| DIST | COUNTY | ROUTE | KILOMETER TOTAL PROJECT | POST PROJECT | SHEET No | TOTAL SHEETS |
|------|--------|-------|-------------------------|--------------|----------|--------------|
| 04 | SF | 80 | 13.2/13.9 | | 118R1 | 1204 |

CONTRACT CHANGE ORDER NO. _____
 SHEET _____ OF _____

CONDUIT PLAN

SAS SUPERSTRUCTURE ROADWAY WESTBOUND LIGHTING AND ELECTRICAL SYSTEMS

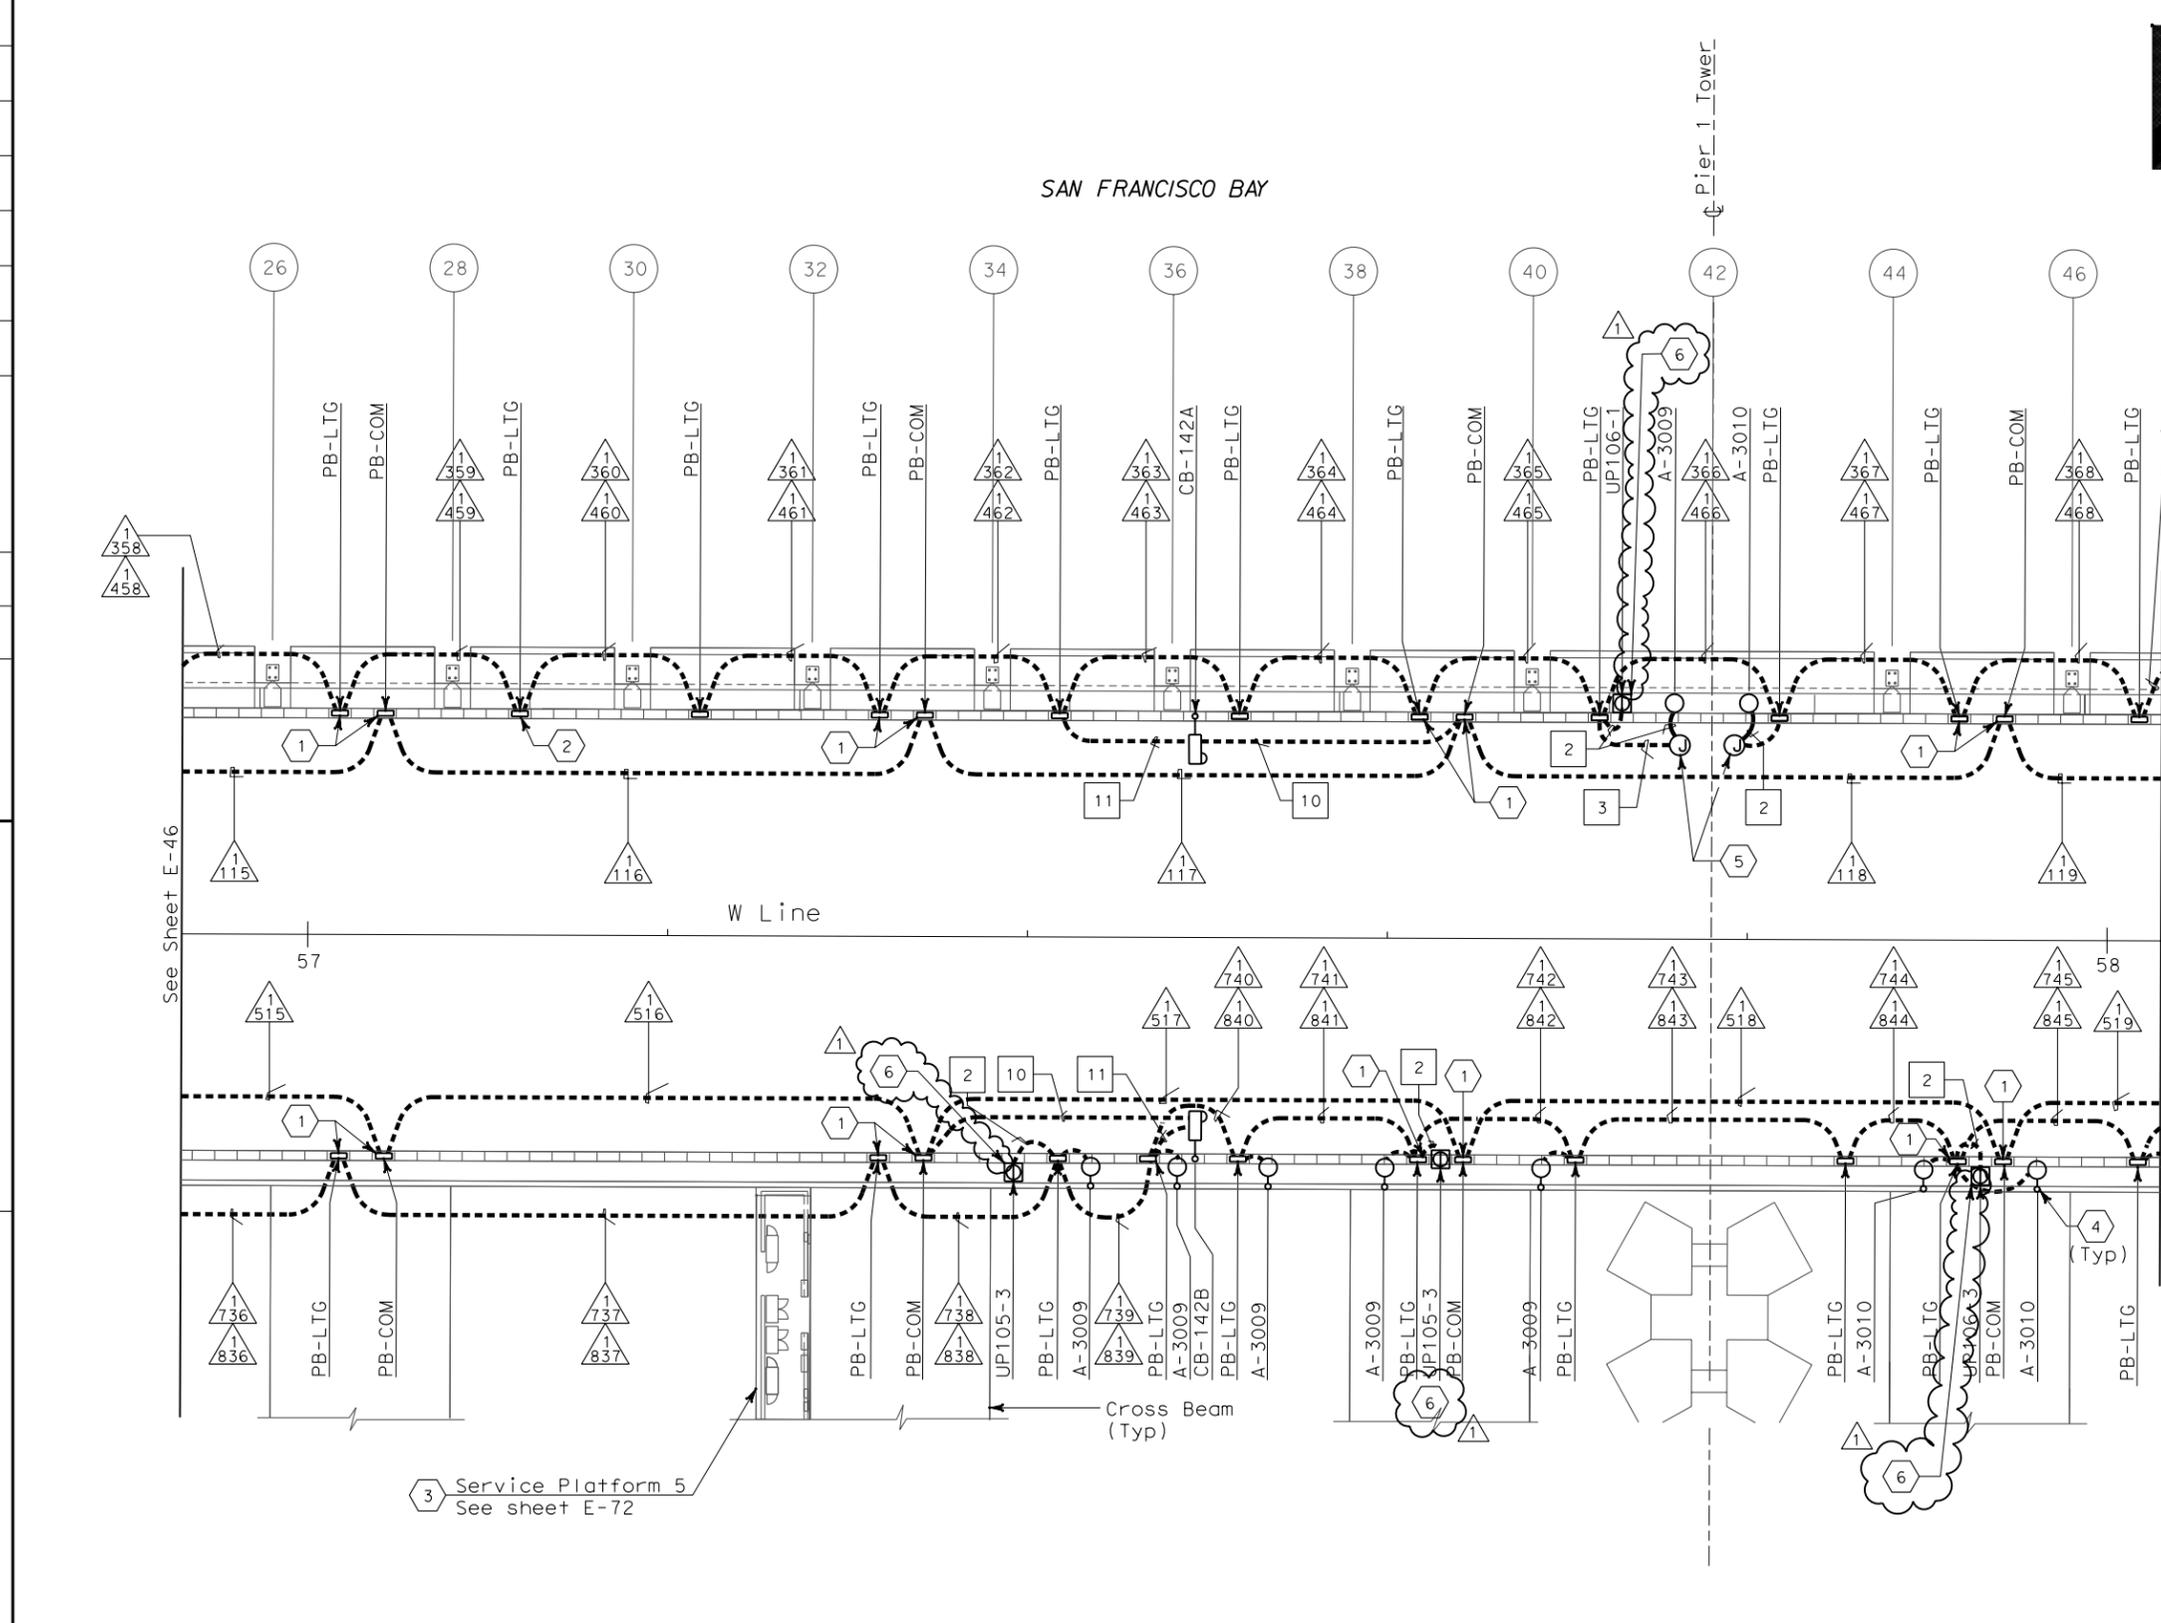
| 1 | 02/19/08 | ELECTRICAL MODIFICATIONS | MP | RR | 42 |
